Access Compliance Report Public Rights-of-Way (Curb Ramps)

Main Street: TRIUMPHAL_WAY Cross Street: FORUM_WAY Location: SW

ADA ID: RPAT211015141957 Ramp Type: Type 1 - Perpendicular Diagonal Initial Pass/Fail: Pass Overall Compliance: No Severity Score: 22

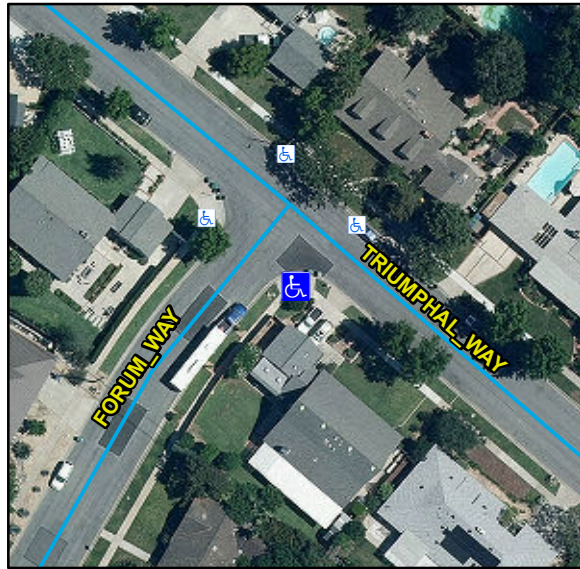
Compliance	Description	Data	Compliance	Description	Data
N/A	Ramp Length (in)	133	N/A	Flare Type LT	
Yes	Ramp Width (in)	64			Sloped
Yes	Ramp Run Slope (%)	5.1	N/A	Flare Slope LT (%)	3.4
No	Ramp Cross Slope (%)	2.3	N/A	Flare Traversable LT	No
N/A	Landing Present	No	N/A	Flare Type RT	
N/A	Landing Length (in)	N/A			Sloped
No	Landing Width (in)	N/A	N/A	Flare Slope RT (%)	2.7
No	Landing Run Slope (%)	N/A	N/A	Flare Traversable RT	No
No	Landing Cross Slope (%)	N/A	No	DWS Provided	No
N/A	Landing Movement Obstructed?	No	N/A	DWS Contrast	N/A
	Landing Movement Type	N/A	N/A	DWS Length (in)	N/A
N/A	Landing Shared	N/A	N/A	DWS Full Width	N/A
N/A	Clear Space	Yes	N/A	DWS Offset Left (in)	N/A
N/A	Clear Space To Crosswalk (in)	48	N/A	DWS Offset Right (in)	N/A
N/A	Marked Crosswalk 1	No	N/A	Marked Crosswalk 2	No
	Crossing 1 Direction	E		Crossing 2 Direction	N
	Marked Crosswalk 1 Width (in)	N/A		Marked Crosswalk 2 Width (in)	N/A

N/A	Ramp Inside Crosswalk 1	N/A	Yes	Ramp Inside Crosswalk 2	N/A
	Crossing 1 Slope (%)	2.8		Crossing 2 Slope (%)	3.9
	Crossing 1 Cross Slope (%)	2.3		Crossing 2 Cross Slope (%)	2.5
Yes	Gutter Ponding	No	N/A	Curb Slope	1.4
Yes	Gutter Lip Height (in)	0		Road Run Slope (%)	0.8
Yes	Gutter Run Slope (%)	3.2		Road Cross Slope (%)	5.7
Yes	Gutter Cross Slope (%)	0.1			
Yes	Overall Surface Condition: Acceptable		No	Perp Joint Present	No
	Cross Gutter Present?	No		Spandrel Present?	No
	Replace Cross Gutter?	N/A		Replace Spandrel?	N/A

Remove & Replace Curb Ramp With Two New Directional Ramps or Equivalent.
